Director's Report

Project Name: 9101 Highland
 Description: Preliminary site plan approval recommendation & special land use approval
 Date on Agenda this packet pertains to: December 5, 2024

RE: 9101 Highland Road-Proposed Commercial Development- Preliminary Site Plan Review – 2nd Review

**Preliminary Site Plan / Special Land Use Review
for
White Lake Charter Township, Michigan**

A-300

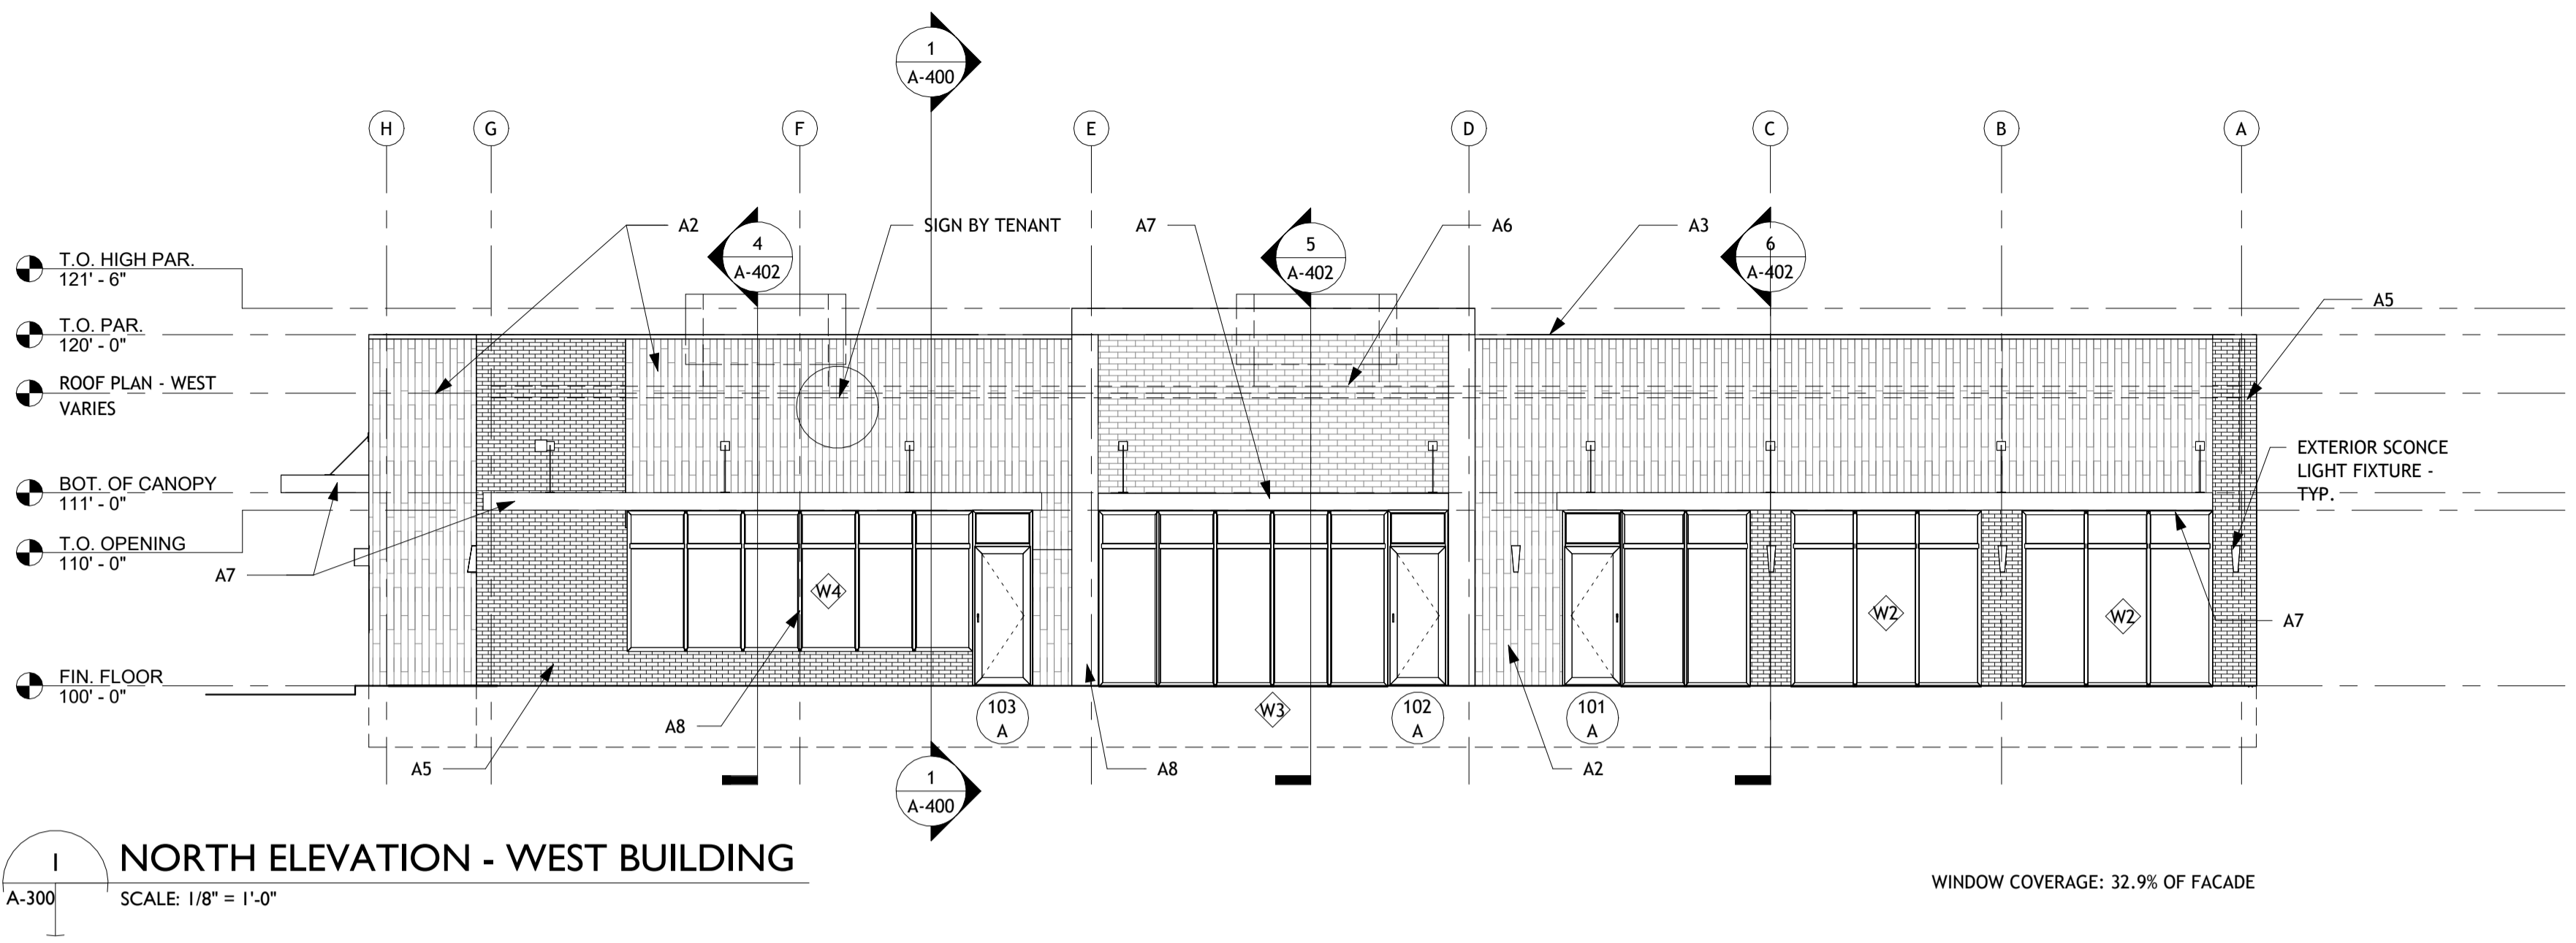
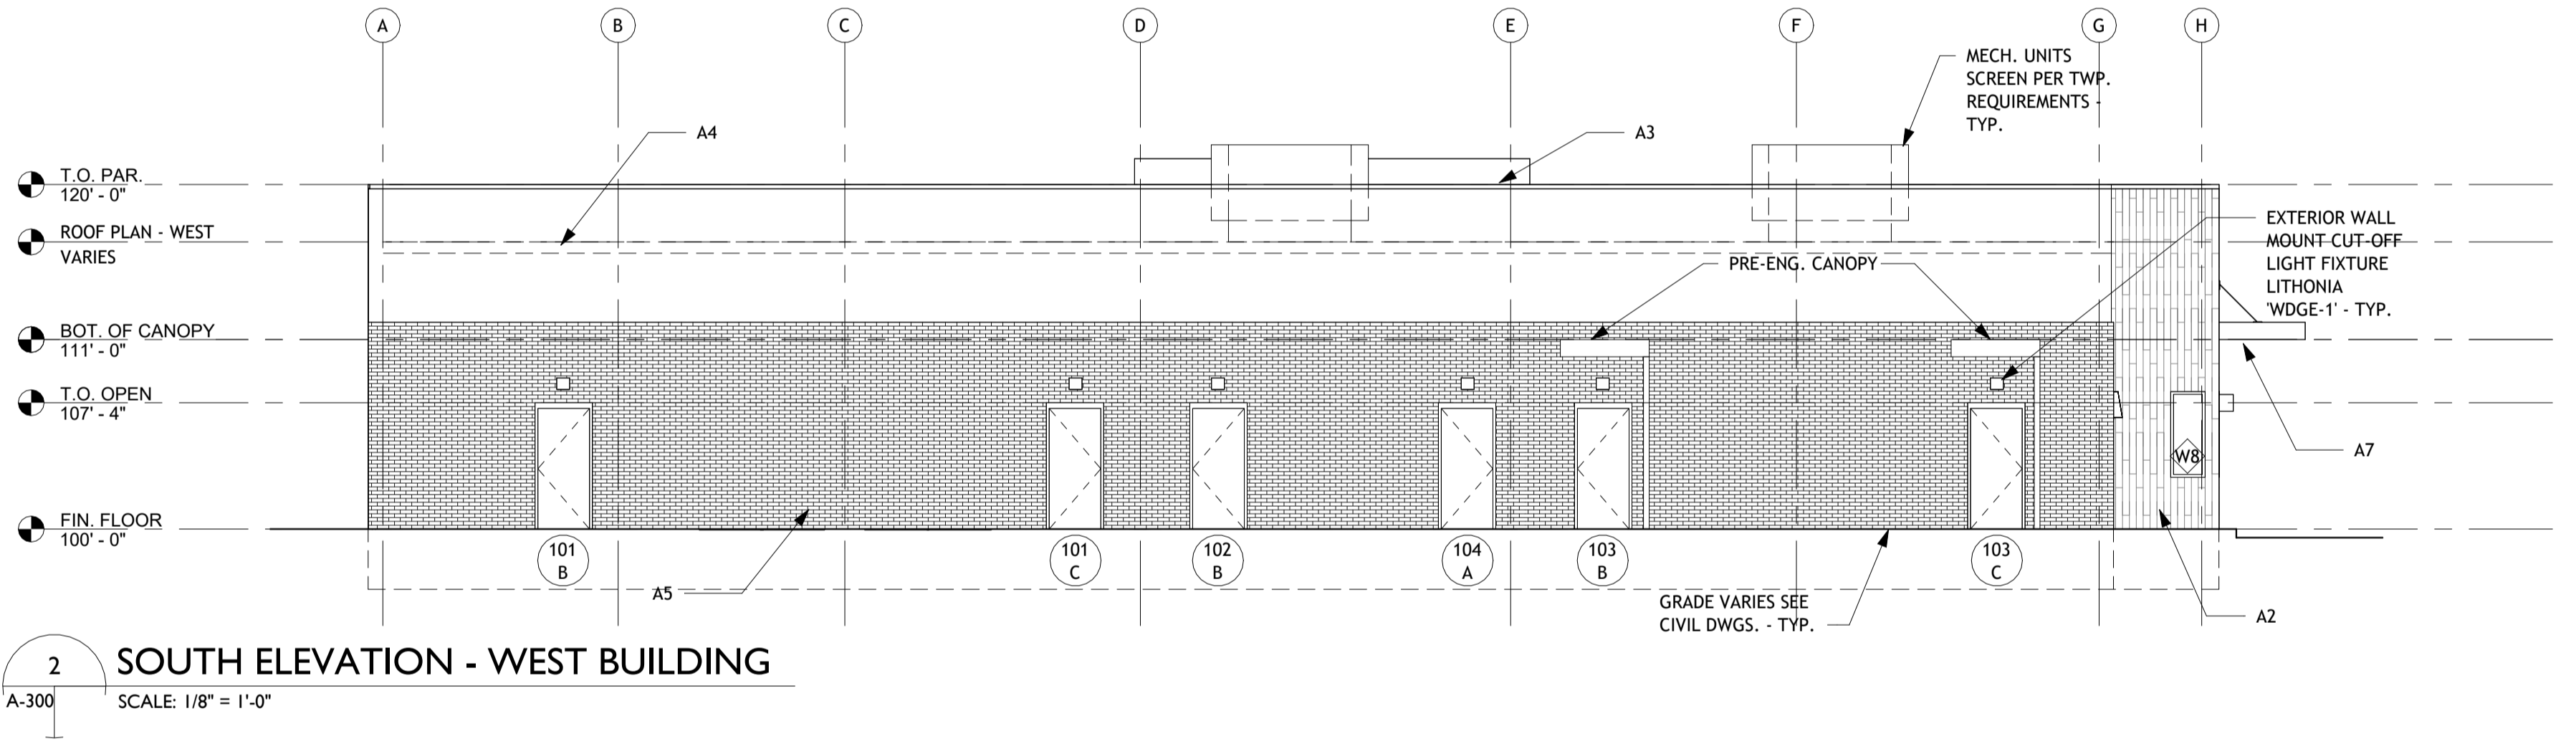
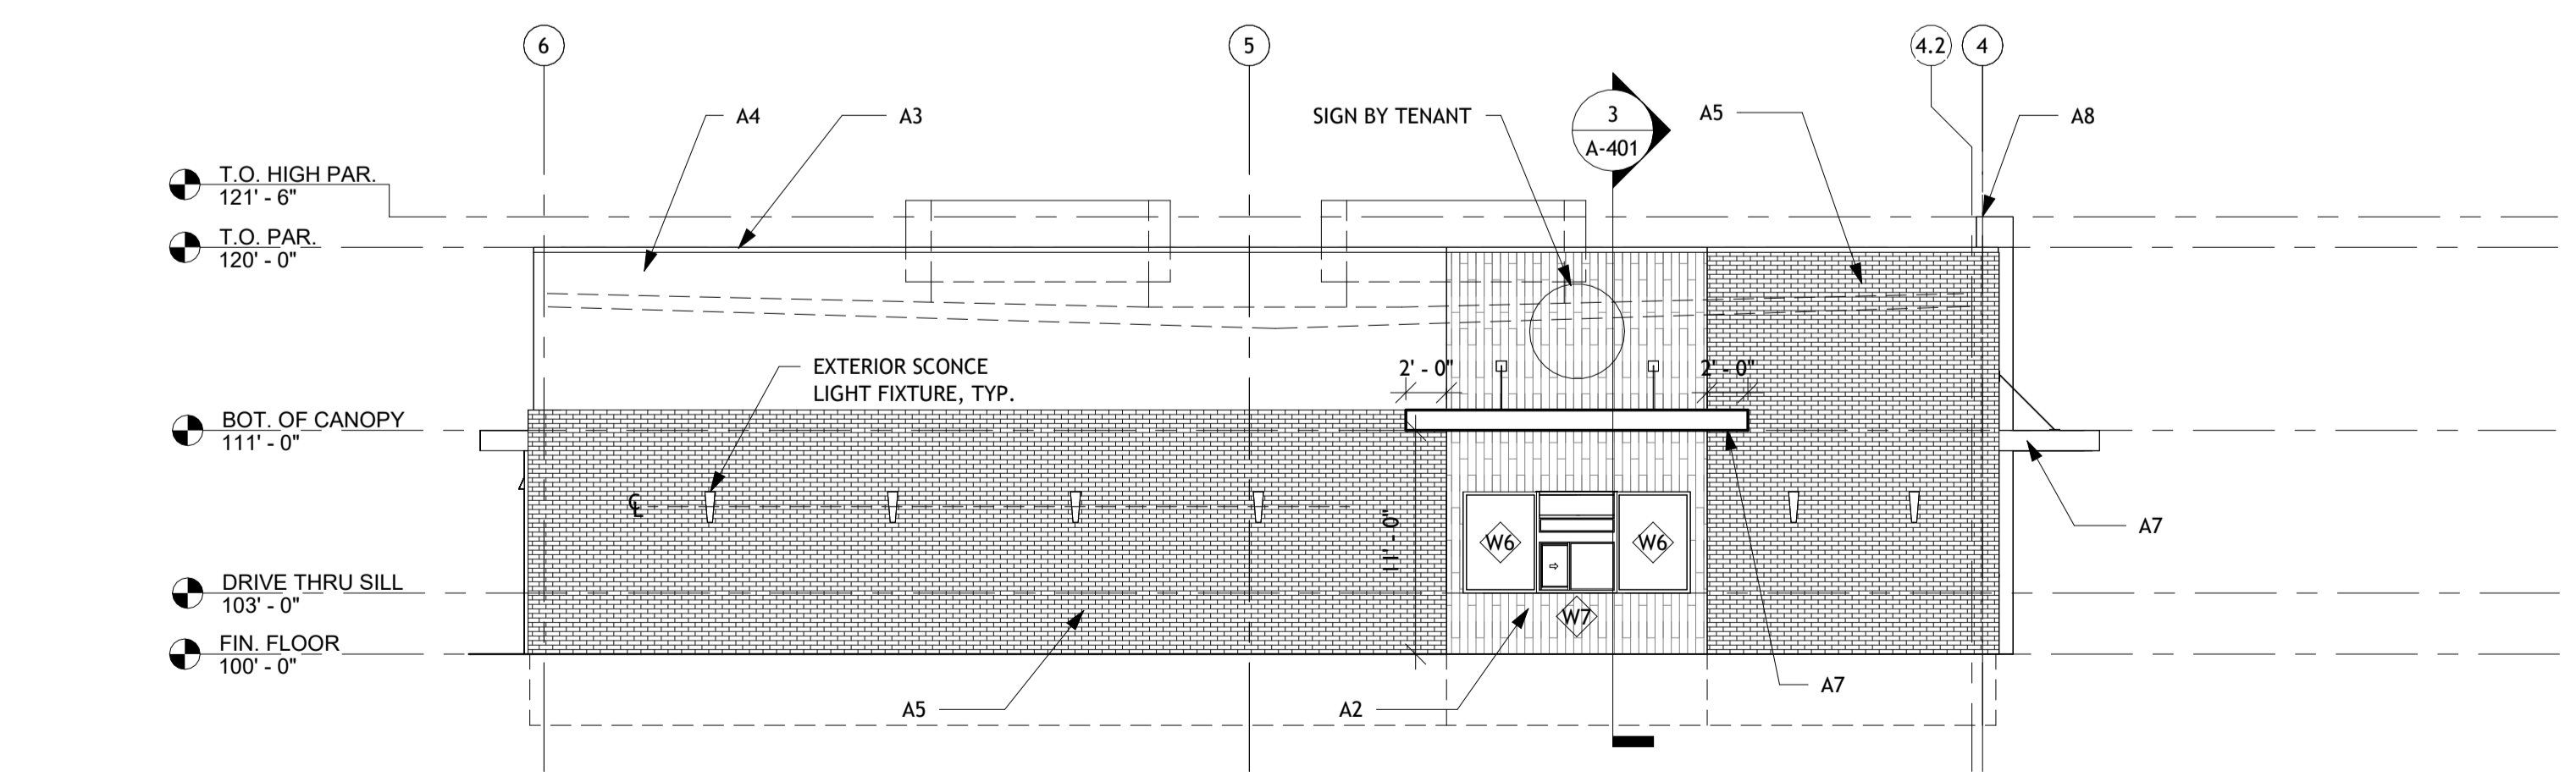
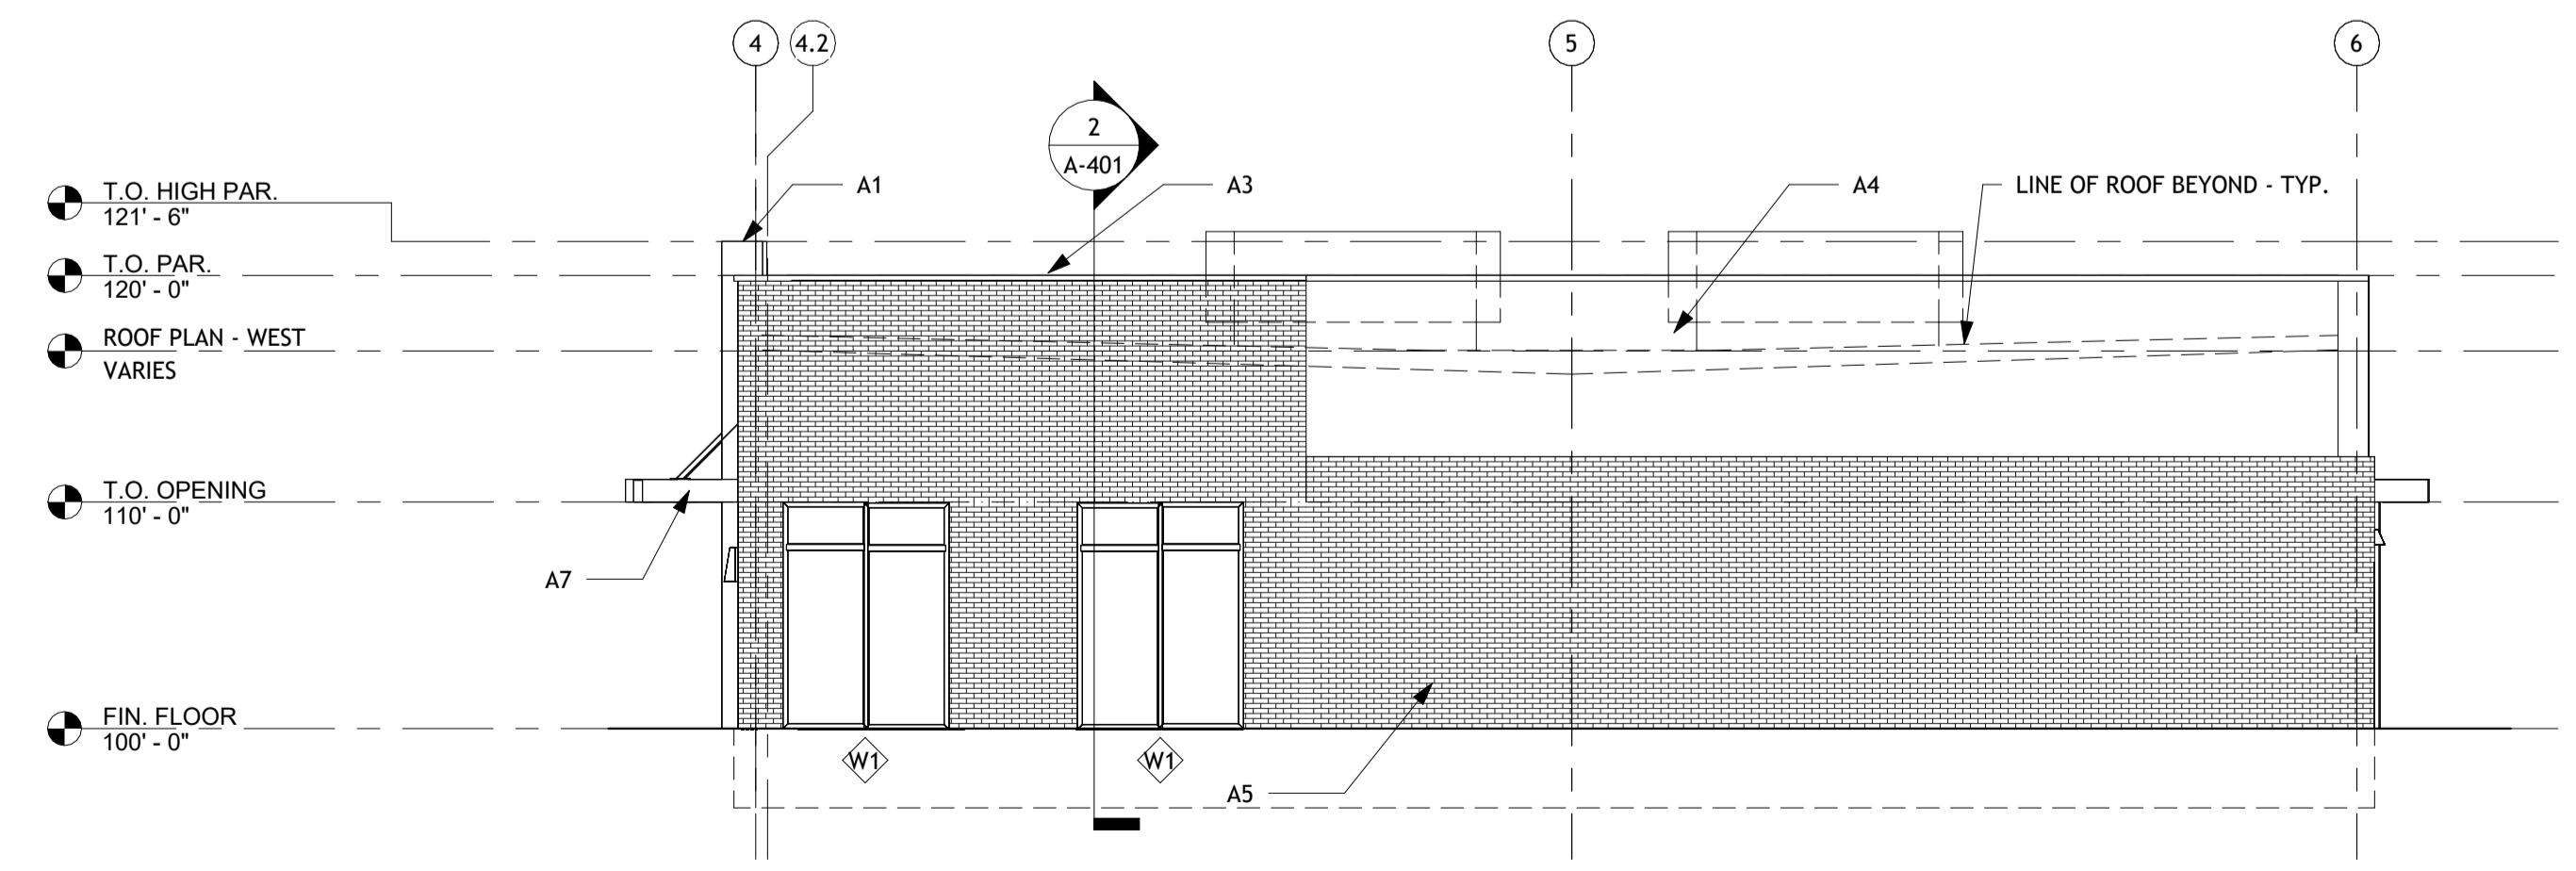
Items to be Addressed: 1.) *Window coverage calculations should be added to exterior elevations facing Highland Road (M-59).* 2.) *Architectural drawings should be stamped and sealed by the professional that prepared them.*
